**AGENDA**  
**ST. TAMMANY PARISH PLANNING COMMISSION MEETING**  
**6:00PM – TUESDAY, APRIL 10, 2018**  
**ST. TAMMANY PARISH GOVERNMENT COMPLEX**  
**PARISH COUNCIL CHAMBERS**  
**21490 KOOP DRIVE, MANDEVILLE, LOUISIANA**

MINUTES OF THE  
ST. TAMMANY PARISH PLANNING COMMISSION MEETING  
6:00 P.M. – March 13, 2018  
ST. TAMMANY PARISH ADMINISTRATIVE COMPLEX, COUNCIL CHAMBERS

COUNTRYSIDE  
PHASE 1  
PUD

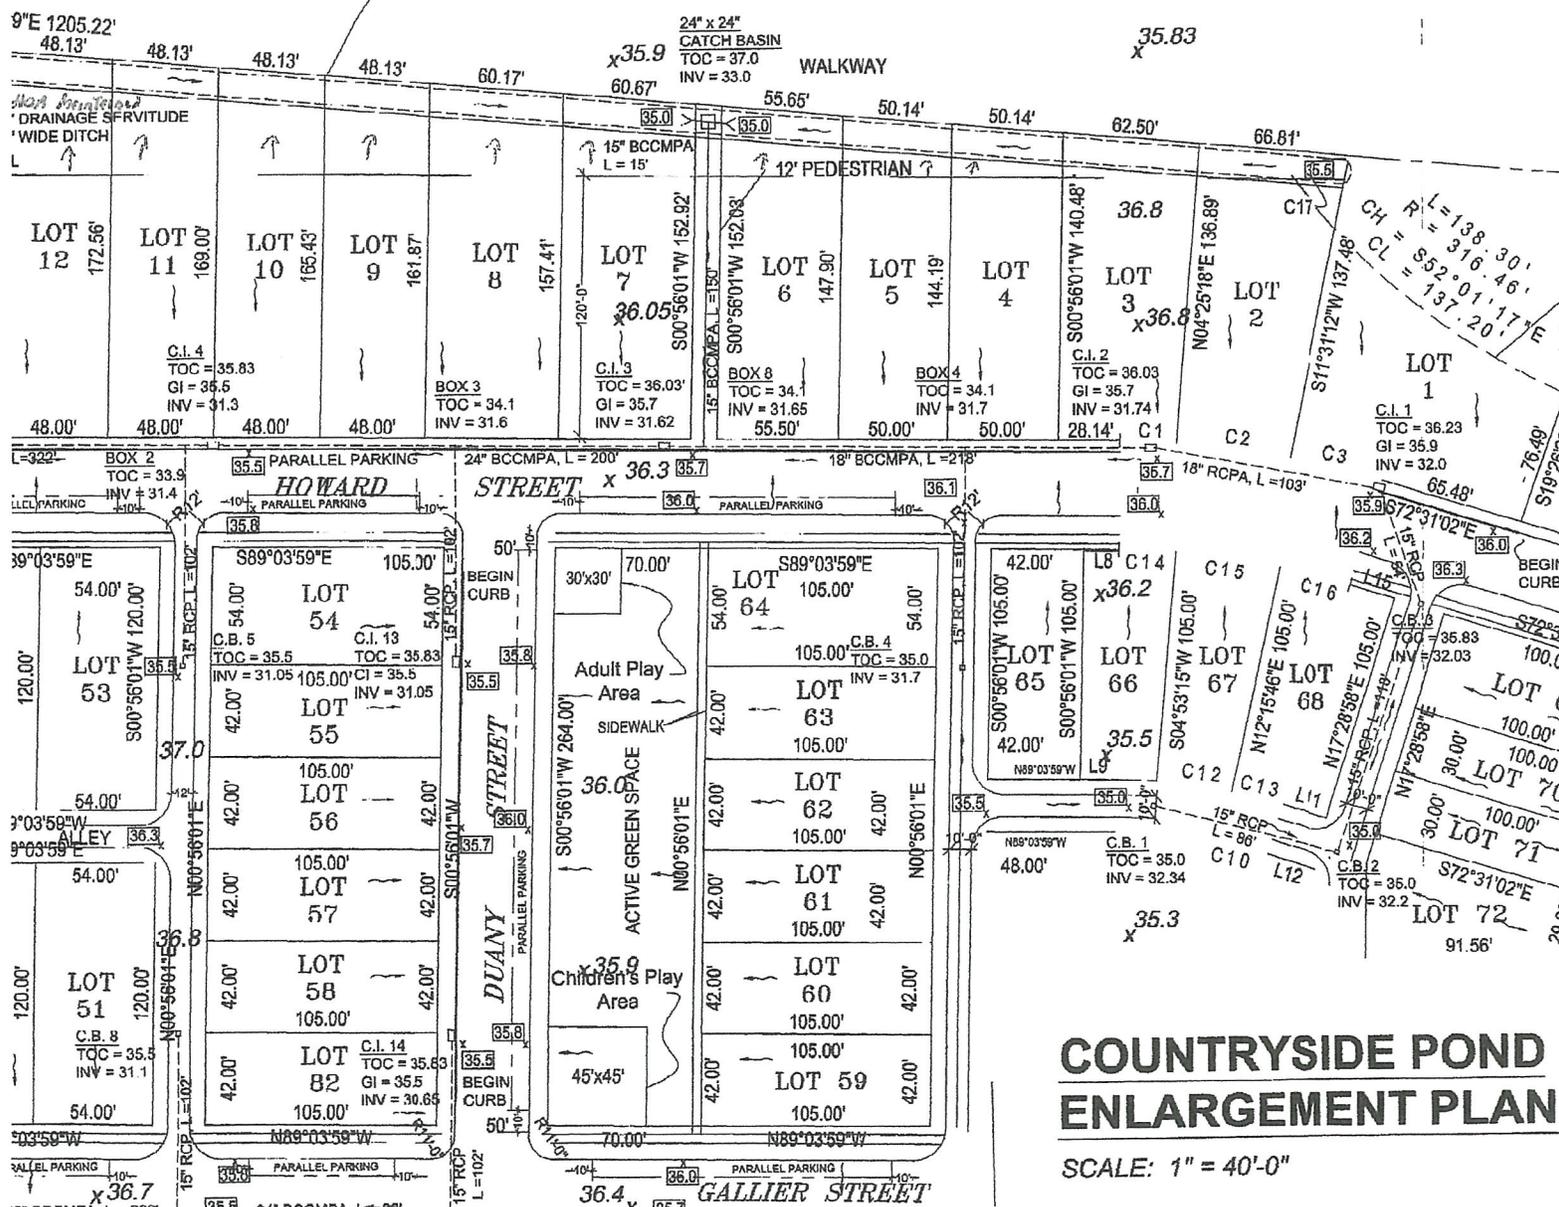
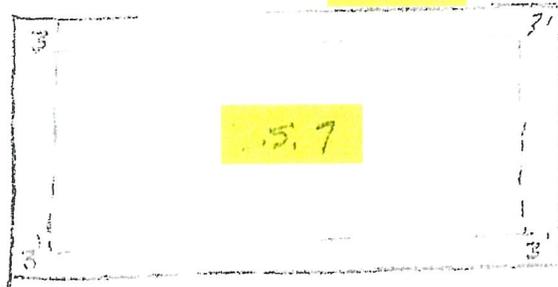
The attached letter dated February 27, 2018 and additional documentation submitted by Mr. Schoen on behalf of Lonesome Development, L.L.C. requests that the Planning Commission remove comment No. 8 from the Final Staff Analysis Report which was granted final approval at the July 11, 2017 Planning Commission meeting.

Comment No. 8 reads as follows: "Certify that the cut volume from the pond mitigates the fill required to bring all lots up to the 100 year flood elevation."

Both preliminary approval and the work order for this subdivision were granted, in part, based on the fact that cut/fill calculations had been submitted and approved. Attached are the approved cut/fill calculations and the pond enlargement plan. Both of these items confirm the requirement for the construction of an additional pond which has not been constructed.

From an engineering standpoint, the existing ponds developed as part of Countryside S/D and subsequently dedicated to Parish Government may be able to provide this floodplain storage, as both subdivisions are located in the same floodplain. If relief is provided by the Board, it is the responsibility of the developer’s engineer to provide updated as-builts for any ponds that they propose to use for the purpose of providing fill mitigation as well as calculations verifying that the ponds can actually provide the fill mitigation volume required.

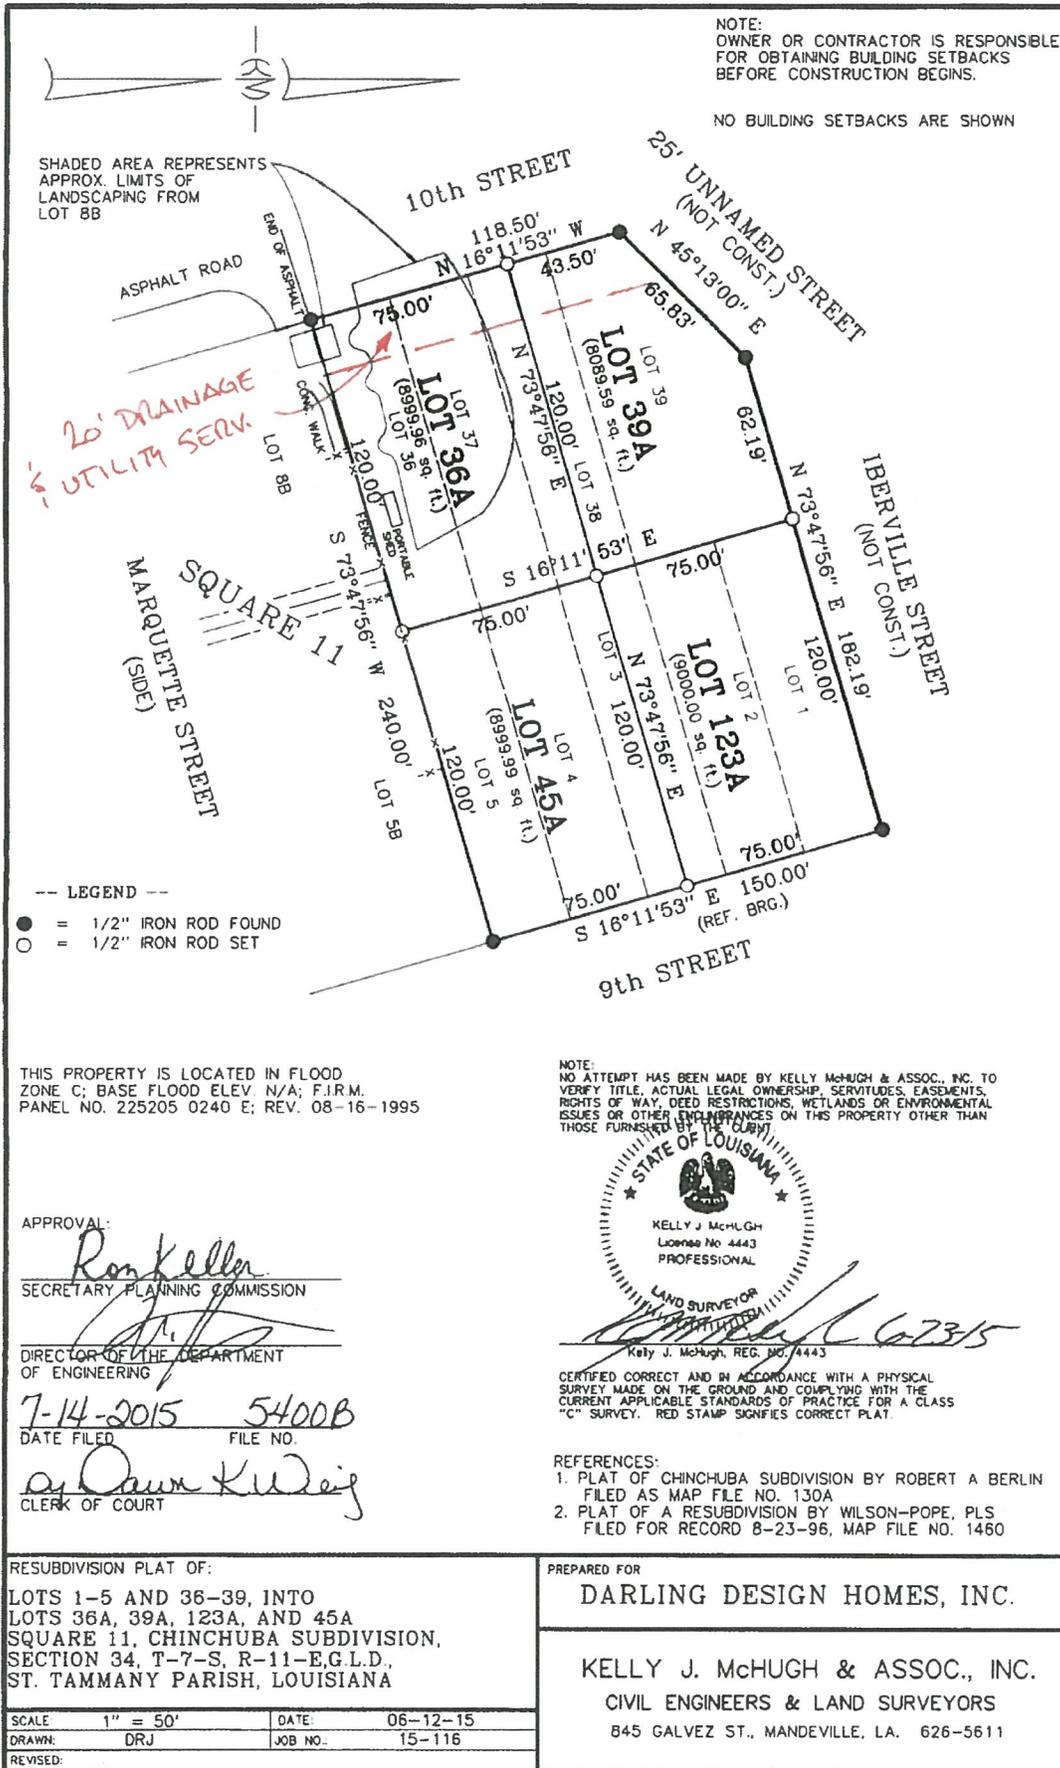
We need to add a drainage and utility servitude to the attached plat. Please let me know if you need anything additional on this act of correction before we send the original up.
